**BERKELEY COUNTY PUBLIC SERVICE SEWER DISTRICT
BERKELEY COUNTY, WEST VIRGINIA**

CONTRACT NO. 7 – TIMBERWALK SANITARY SEWER EXTENSION

ADDENDUM NO. 1

SHEET No.
3

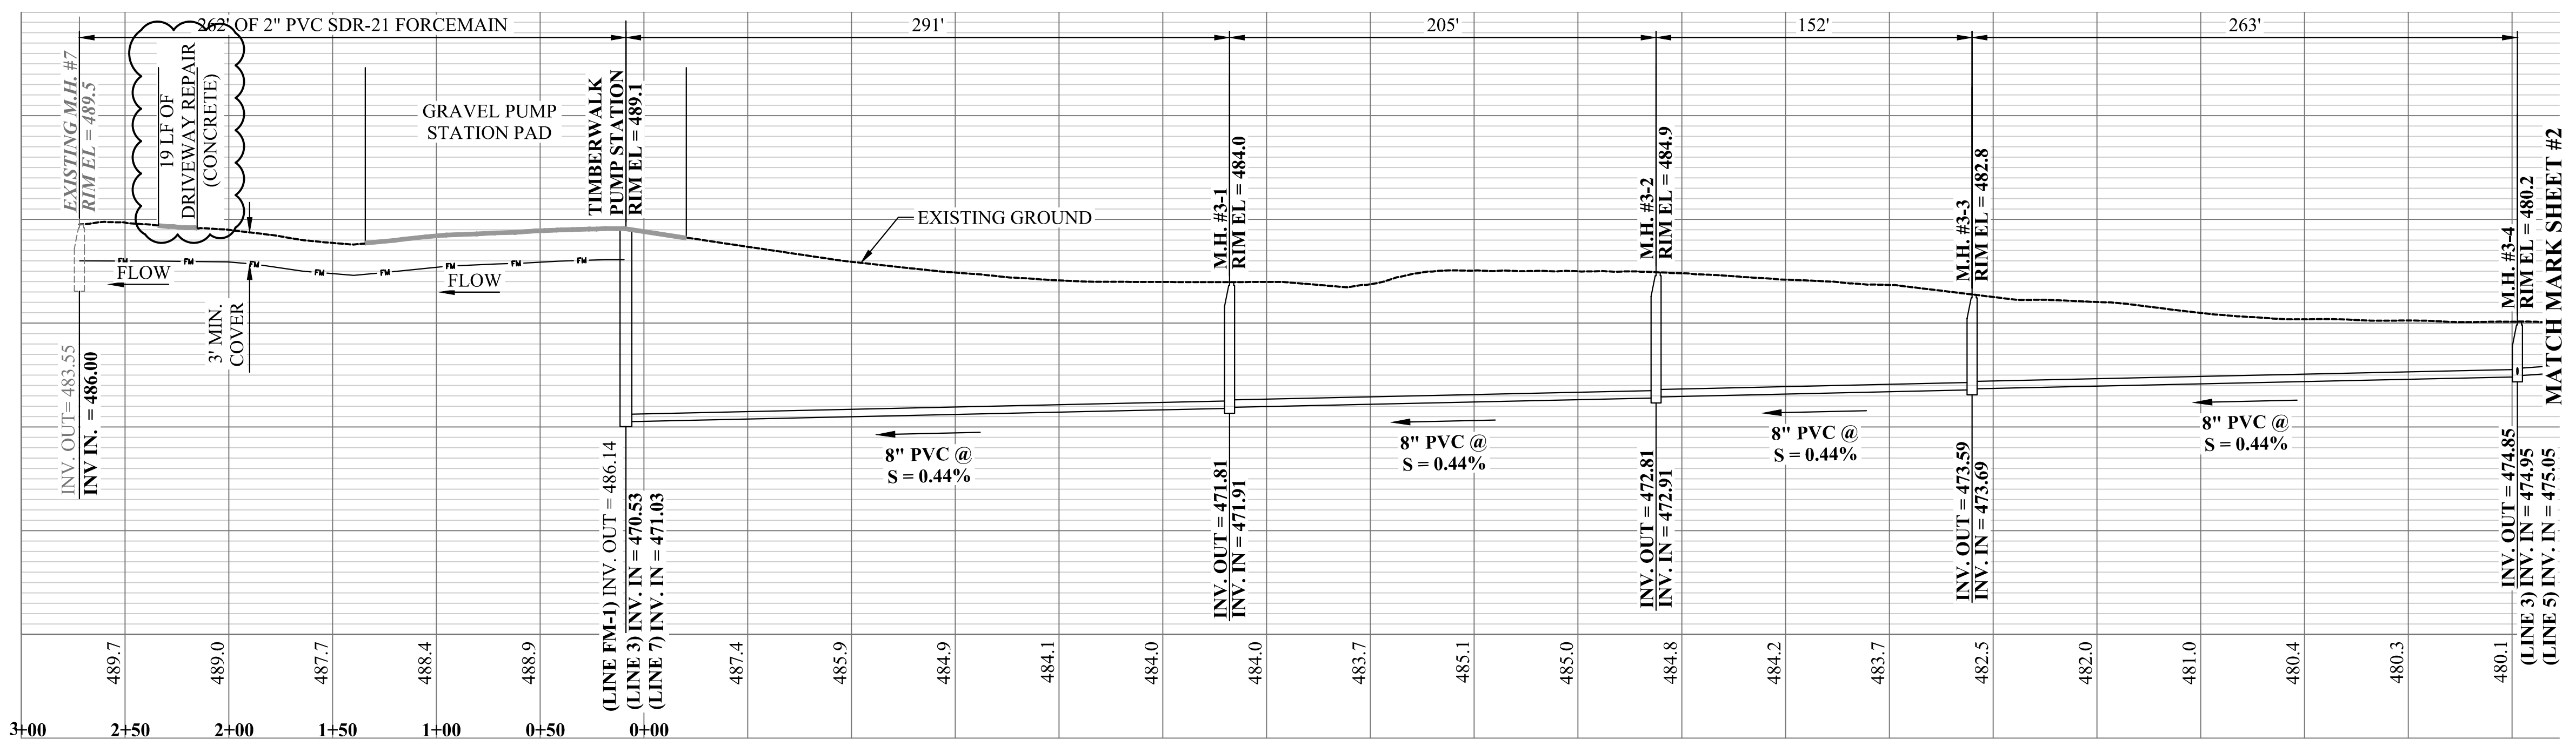
6. **Question:**

The forcemain line goes through a concrete driveway and there does not appear to be a bid item for this. Is this inclusive in the project?

Yes, this is inclusive in the project. Refer to the revised Sheet 3 included with this Addendum No. 1. The Bid Form Section C-410 and Specification Section 012000 – PRICE AND PAYMENT PROCEDURES have been revised to modify the quantities and is included with this Addendum No. 1.

SHEET No. **PS-2**

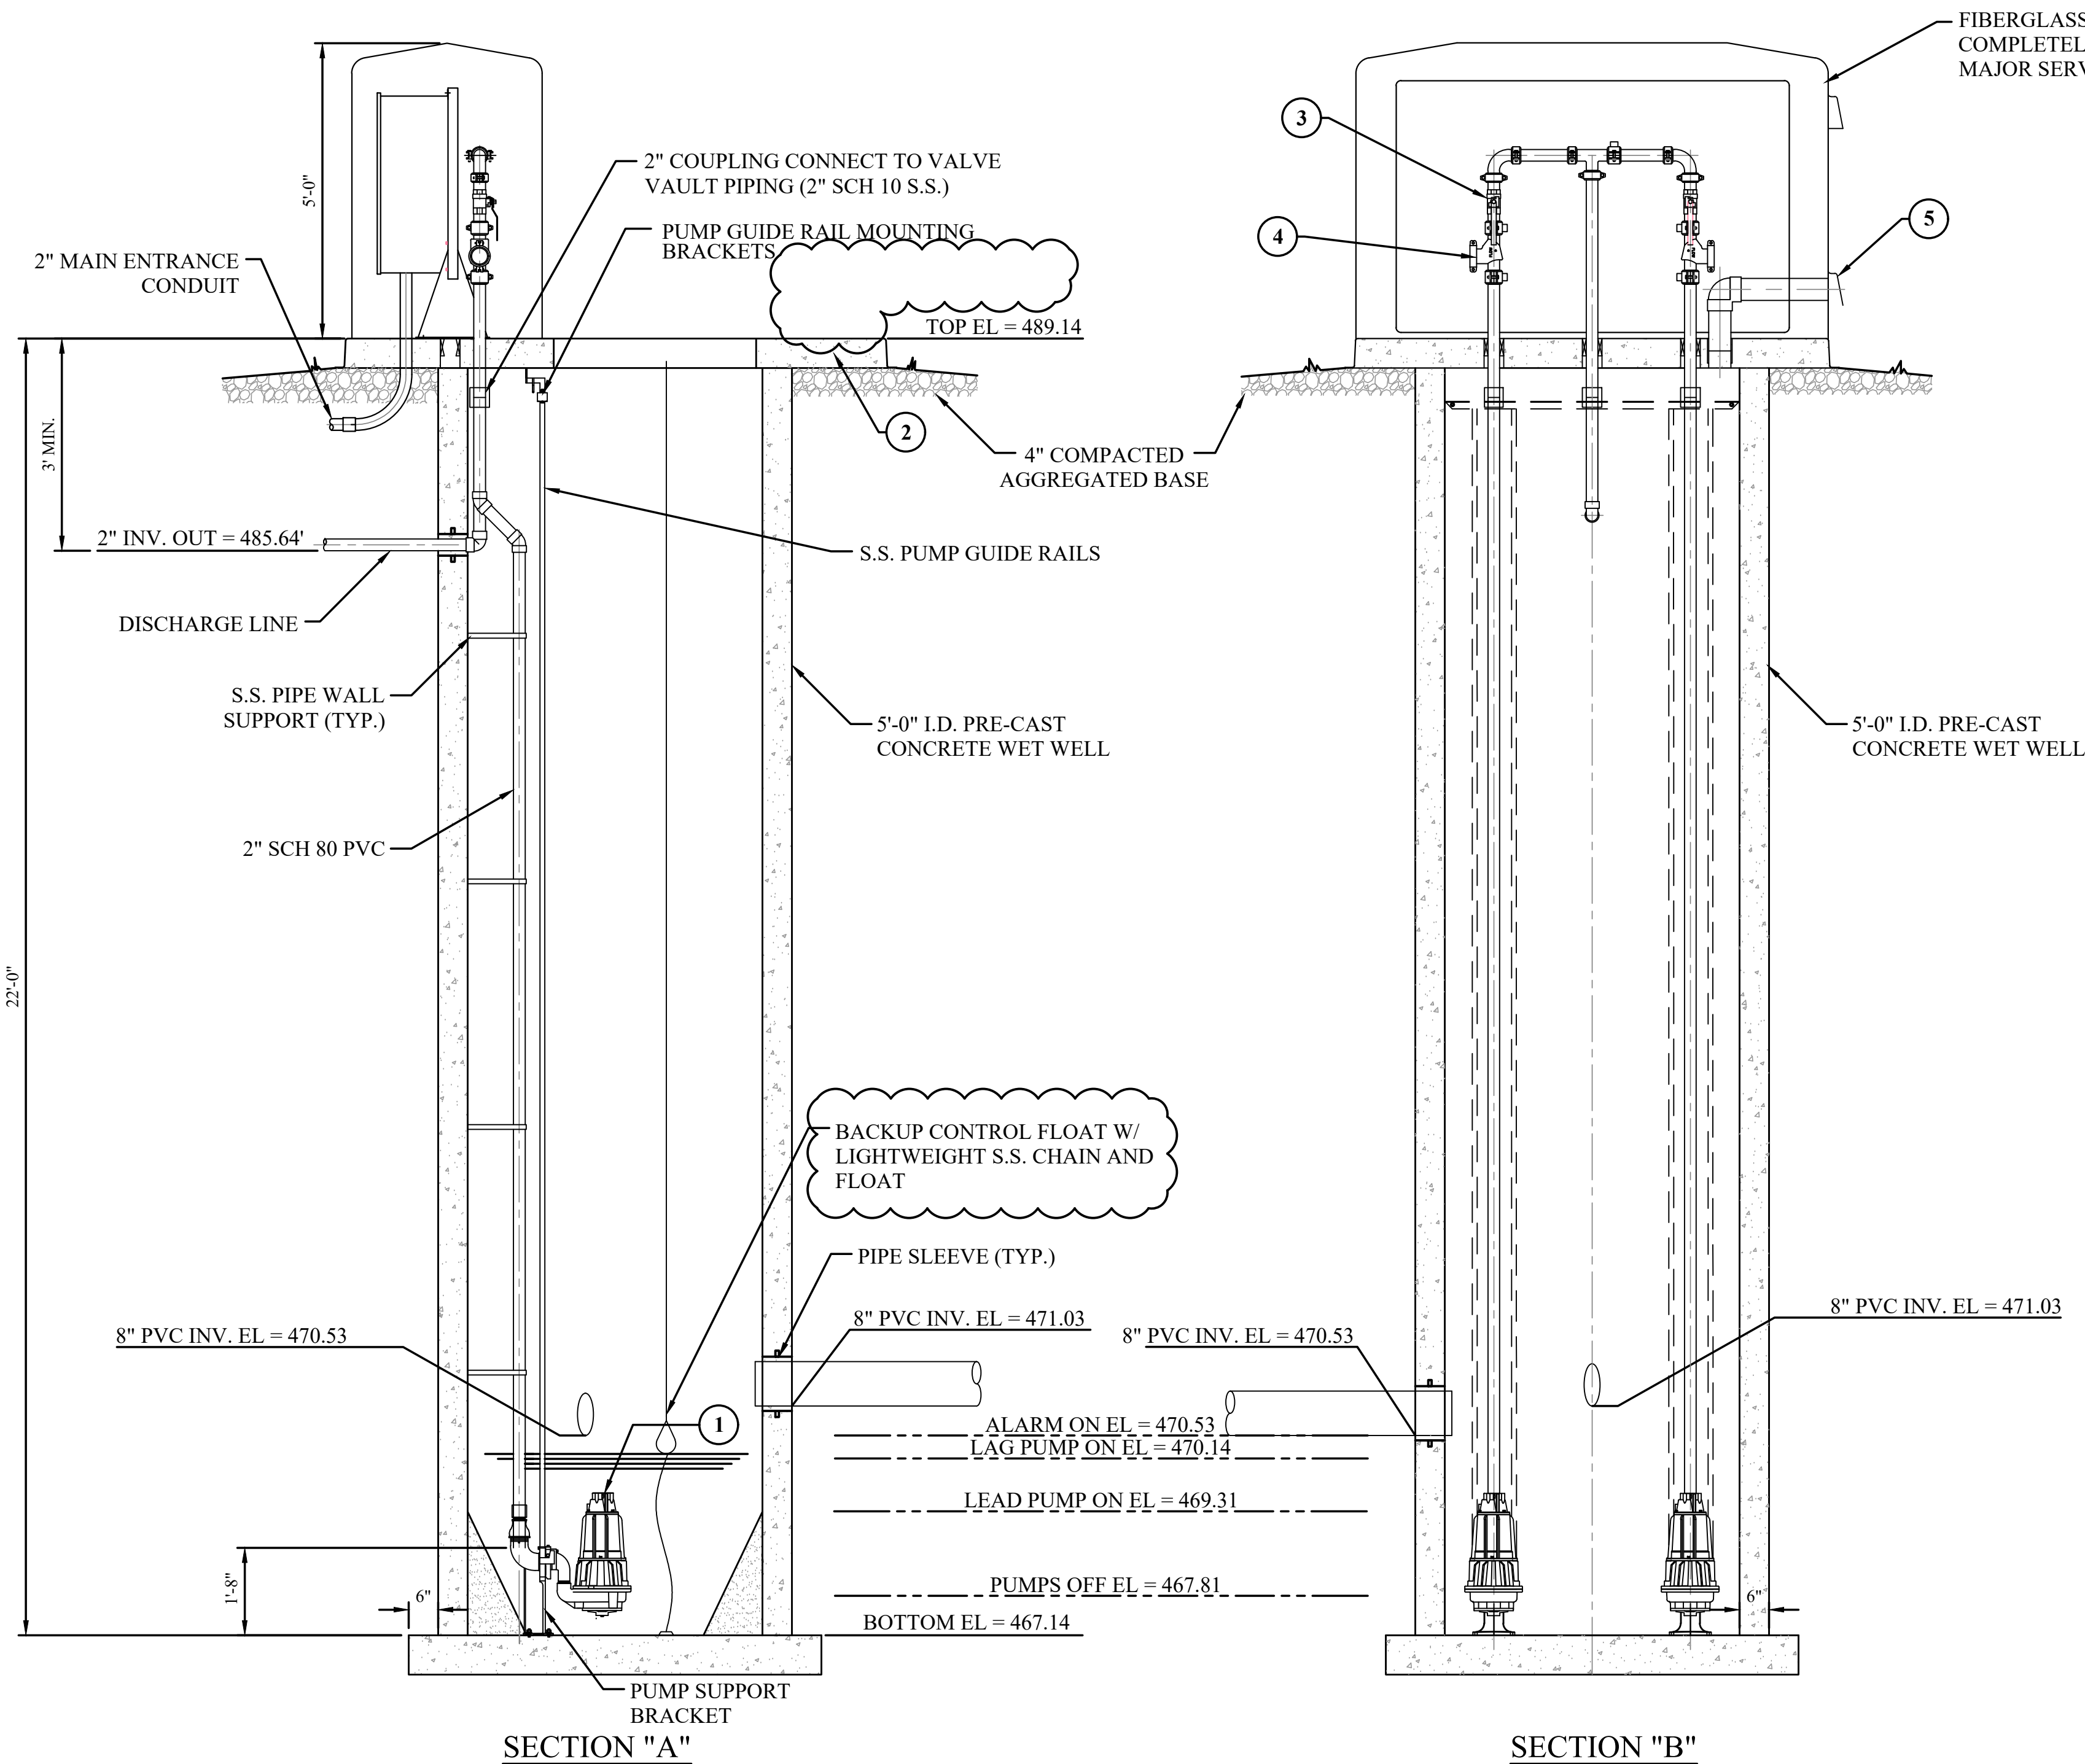
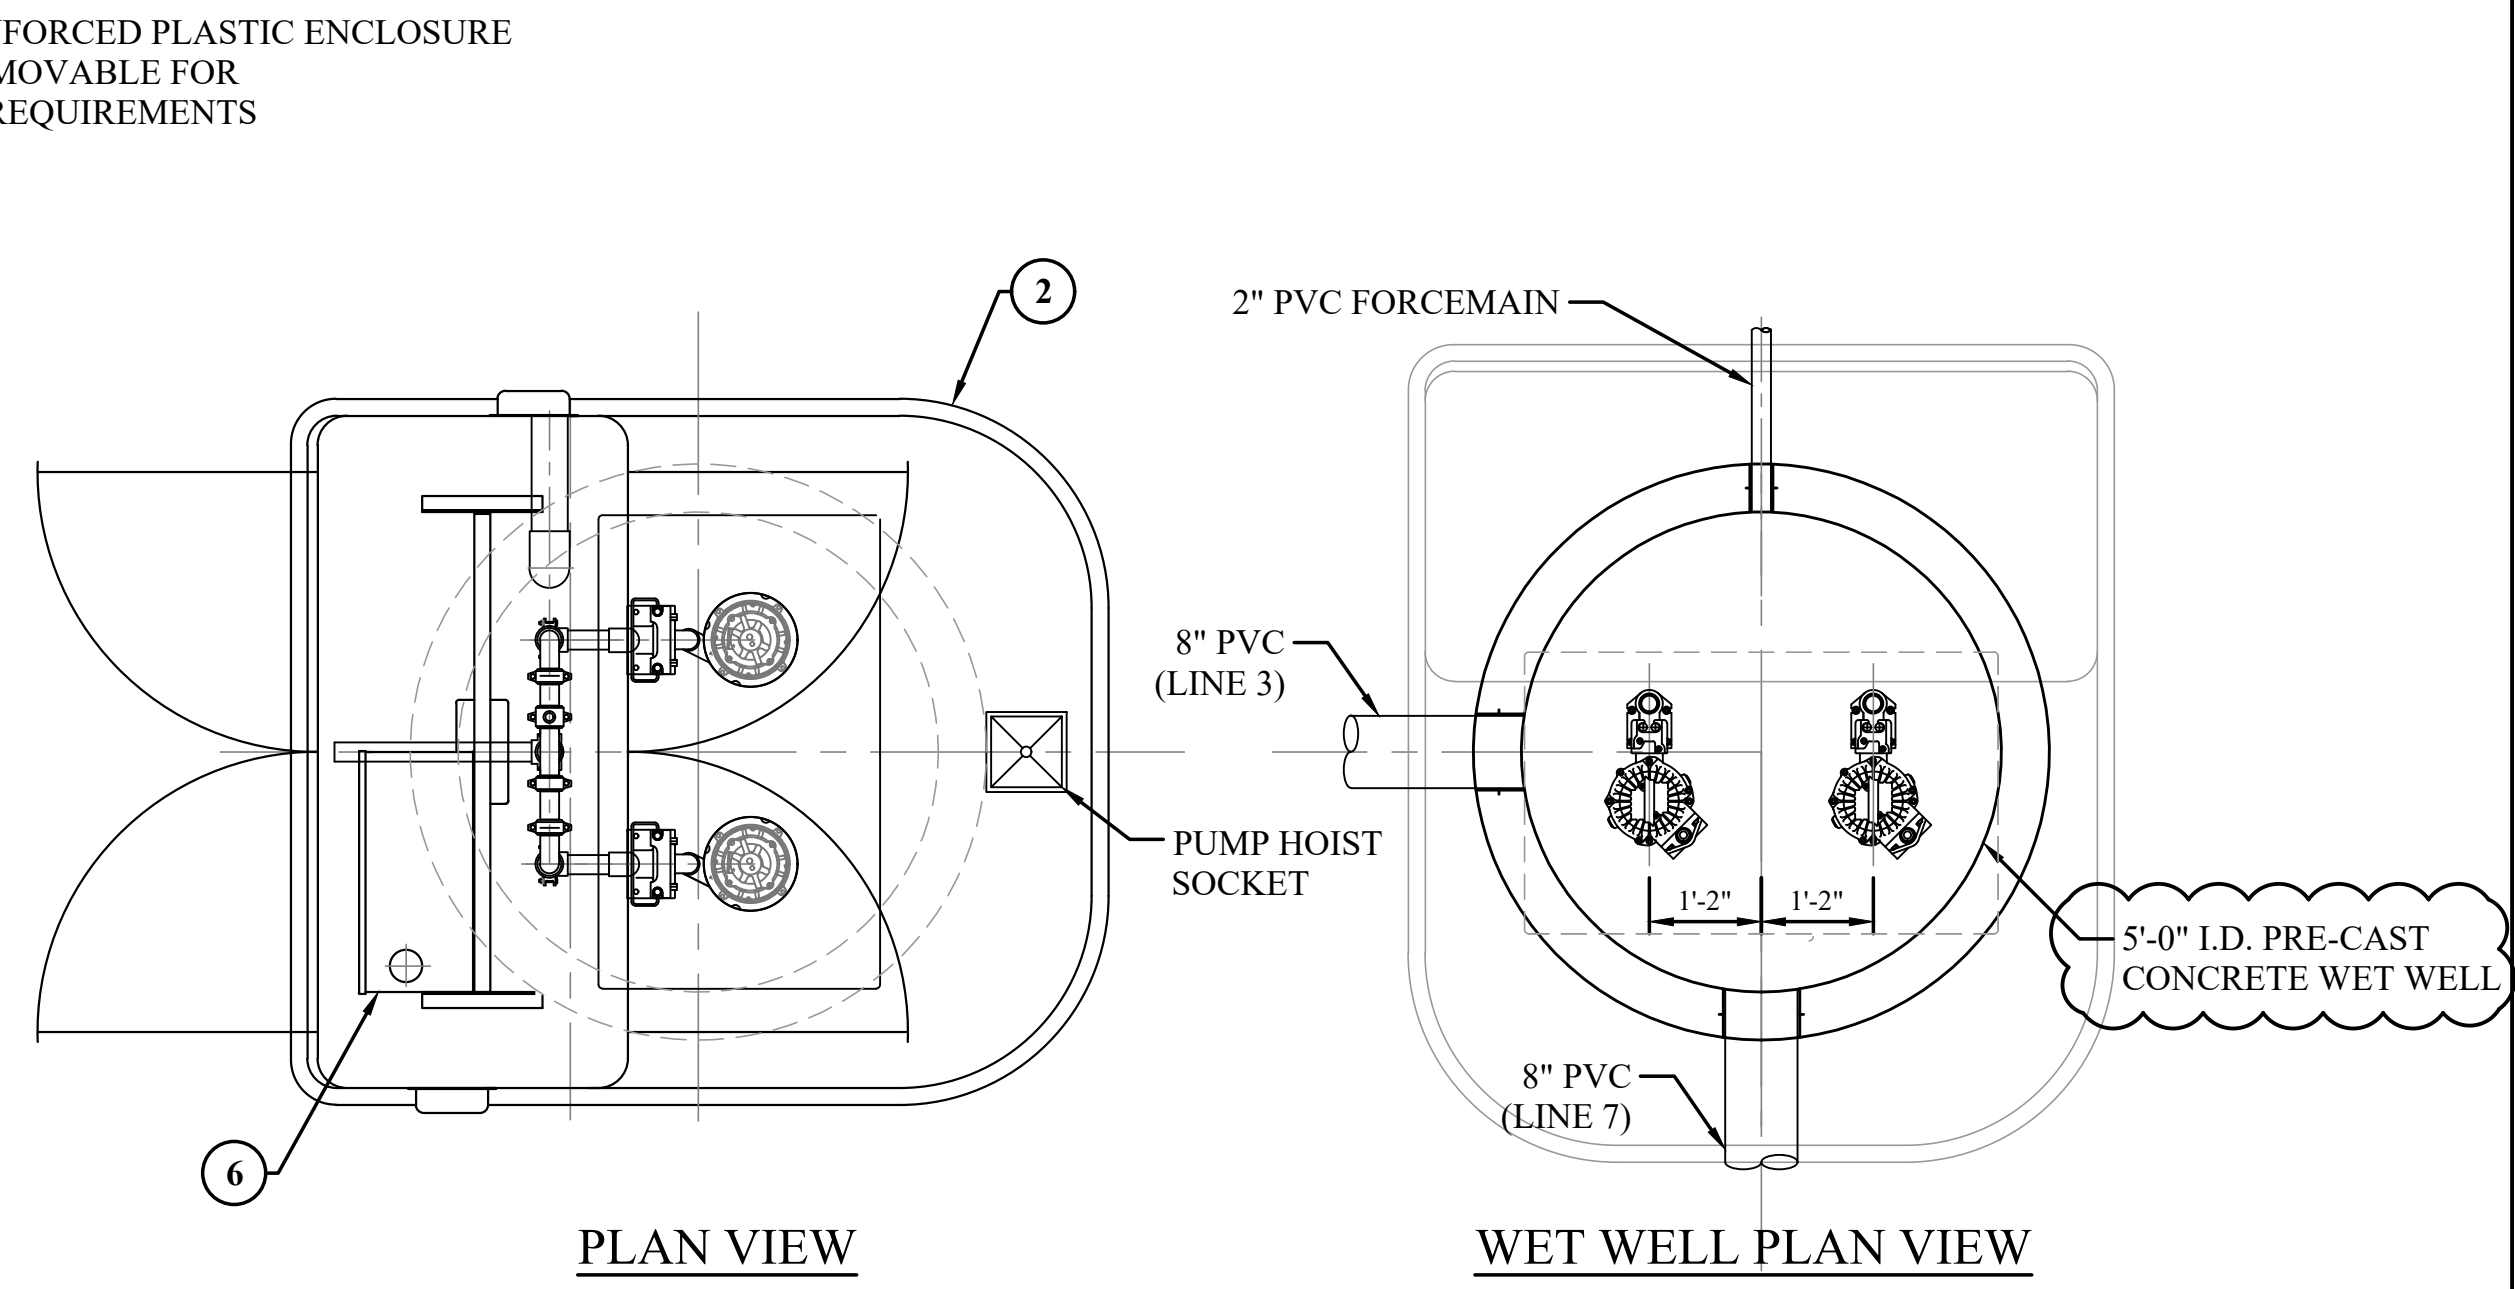
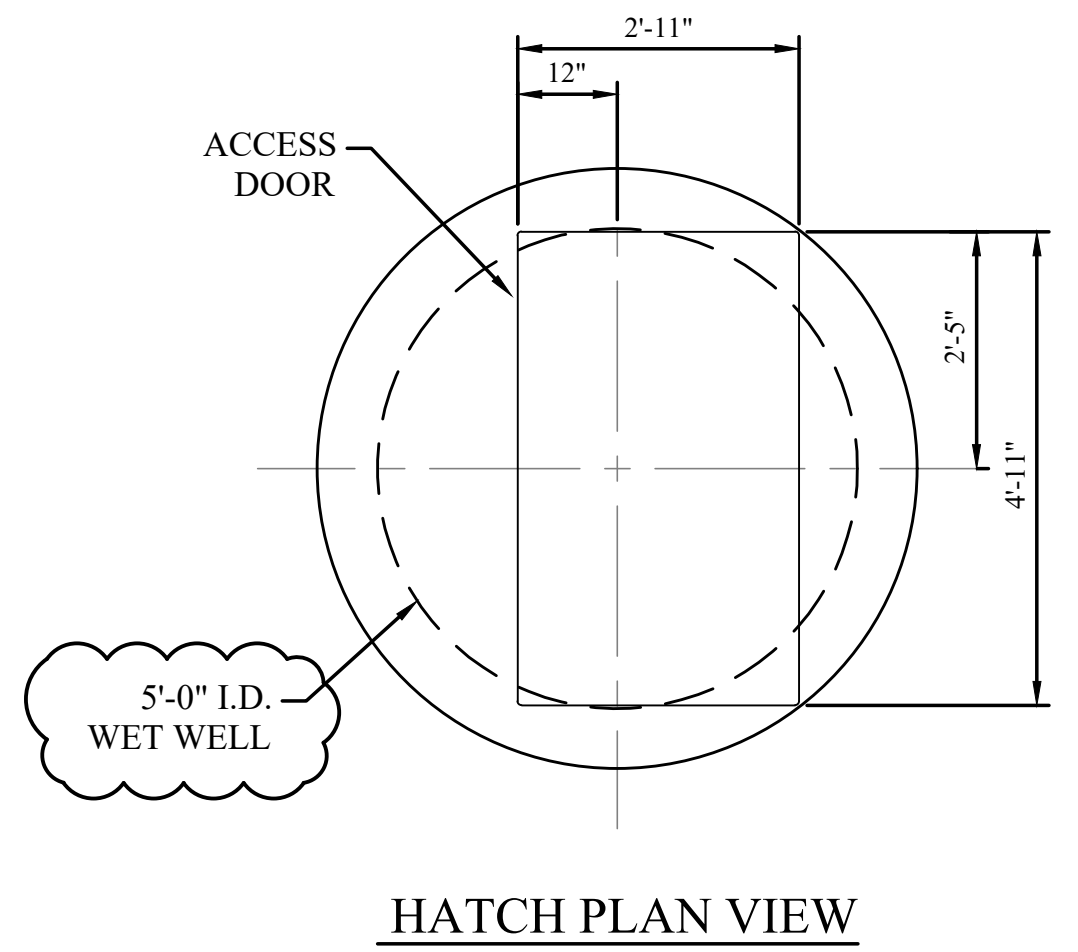
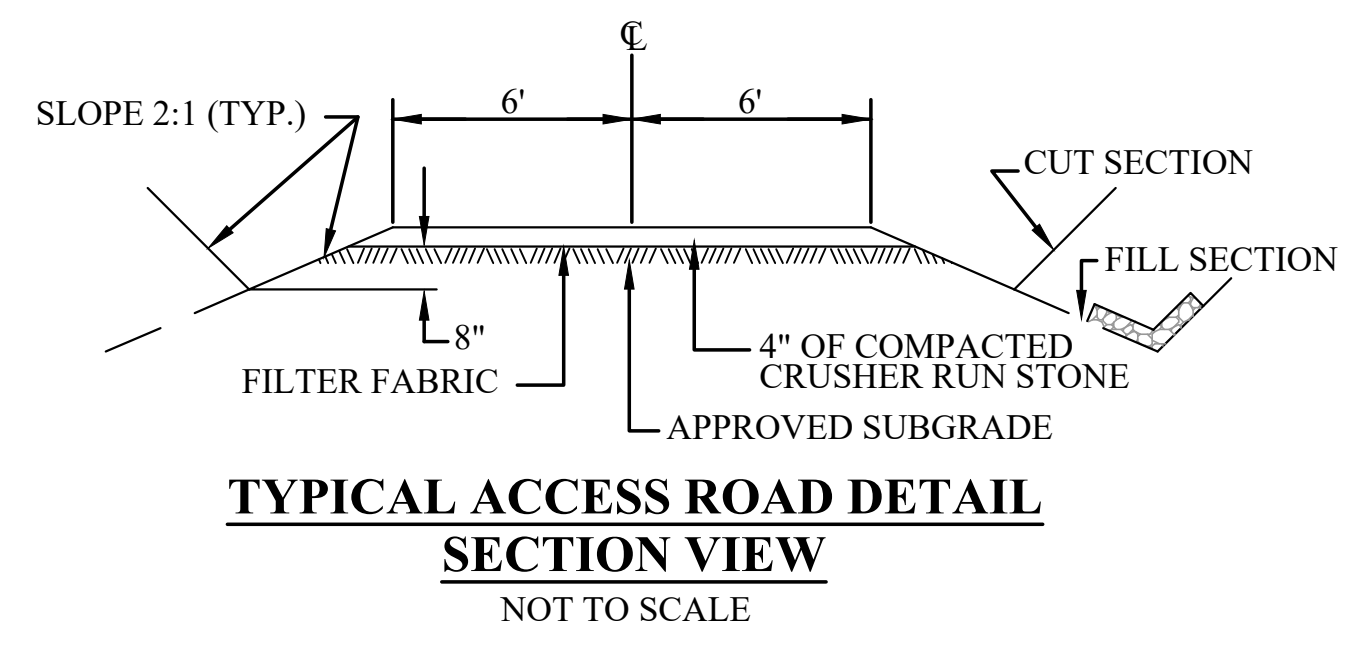
5. **Question:**

Is the wet well 4-foot or 5-foot diameter? There are conflicting notes about this on the Drawings.

10. **Question:**

The valve schedule calls out 4” valves, the drawings and specifications are based on 2” check and isolation valves.

The wet well is 5-foot inner diameter. Refer to the revised Sheet PS-2 included with this Addendum No. 1.

The valve schedule has been revised to match the 2” valves that are called for on the Drawings and Specifications. Refer to revised Sheet PS-2 included with this Addendum No. 1.
